From: David Pickford <[REDACTED]>
Sent: 19 September 2019 14:16
To: Anita Gardner <[REDACTED]>
Subject: FW: 22 Beach Road, Littlehampton.

Subject: 22 Beach Road, Littlehampton.
Importance: High

I write further to the client providing me with your feedback on the AASL acoustic report dated 6th June 2019 for the above site.

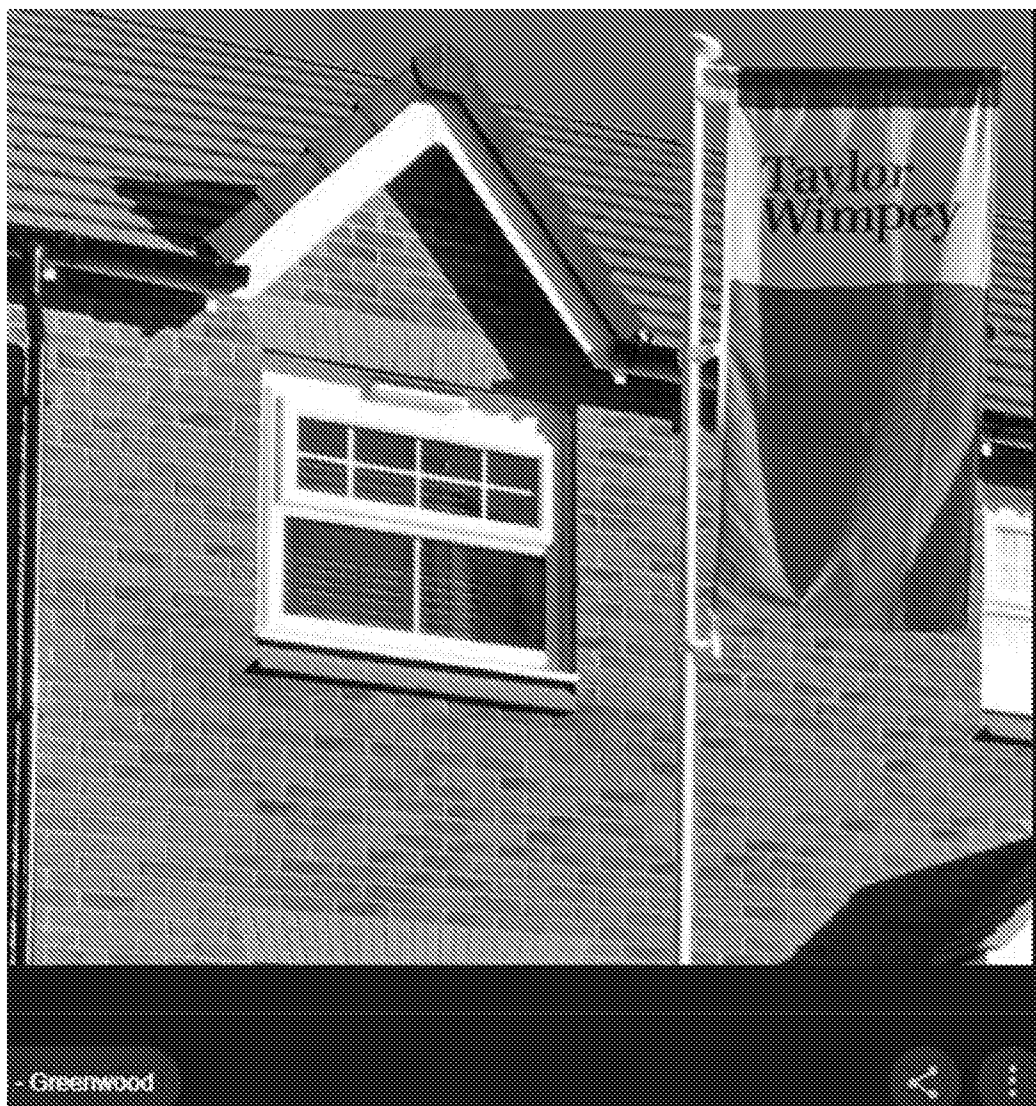
Before the applicant's noise consultants finalise their report in line with the discussions below with Carol Reynolds; as per below, can I get your confirmation that the proposed window acoustic vent (Greenwood 5000EA) shown on the attached specification sheet, required in relation to the noise mitigation discussed below, would be acceptable in terms of external appearance of the building please?

For reference, please see photo below of this vent installed to a window. As you can see the vent would have a negligible impact to the external appearance of the building and is arguably de minimis and does not require planning permission in itself.

For clarification, the vents will be installed in each habitable room.

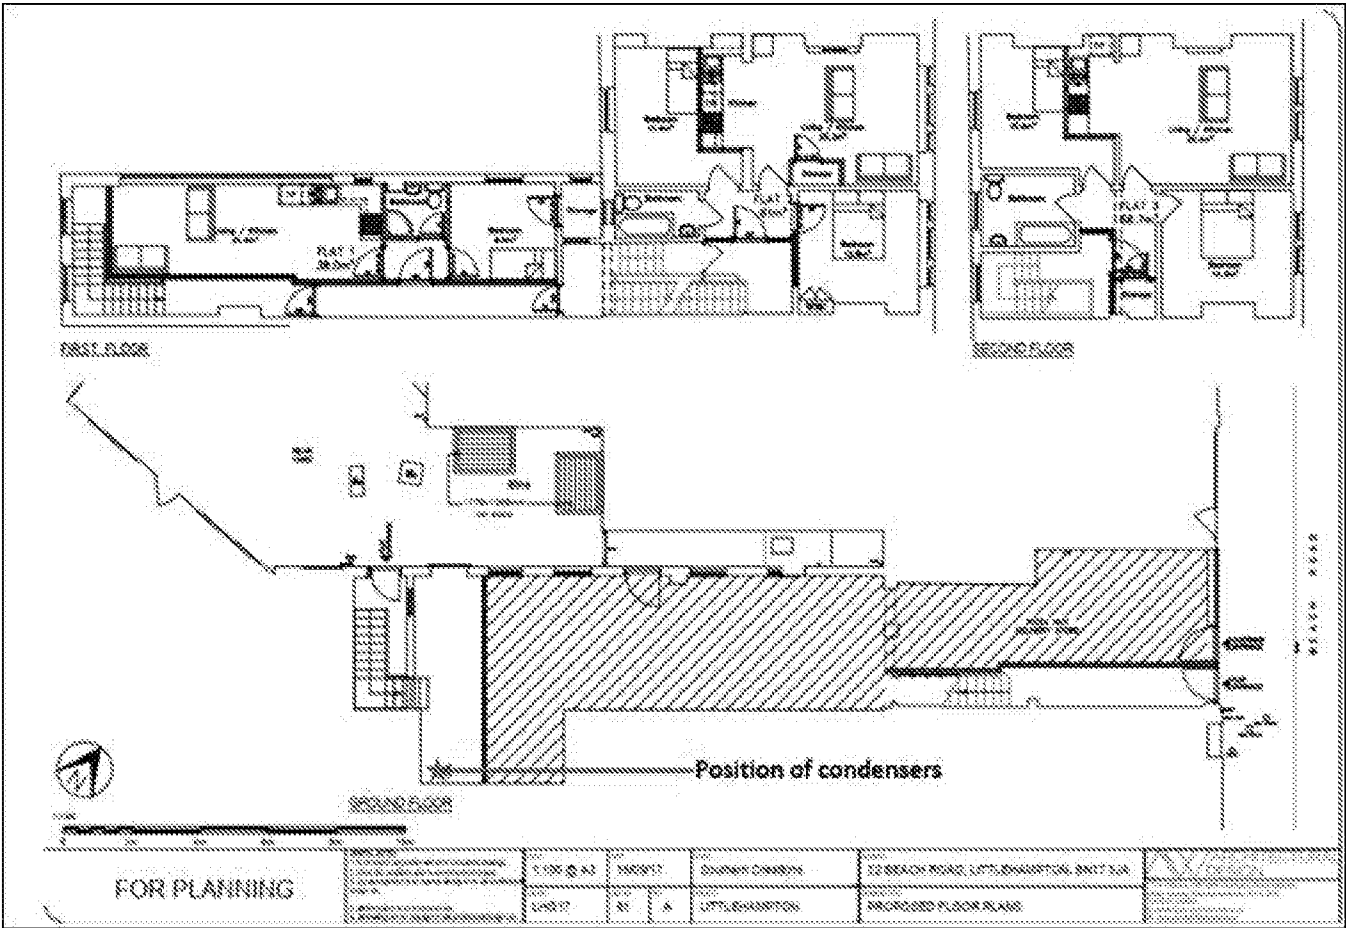
The condensers were previously located below the bedroom window but have since been relocated to inside the rear garage unit at the very rear of Flat 1, outside the demise of the flat.

The condensers are mounted on anti-vibration mounts on the ground floor. Both the garage and the pizza hut ceiling were soundproofed at the same time. The condenser positions inside the garage void are shown below.
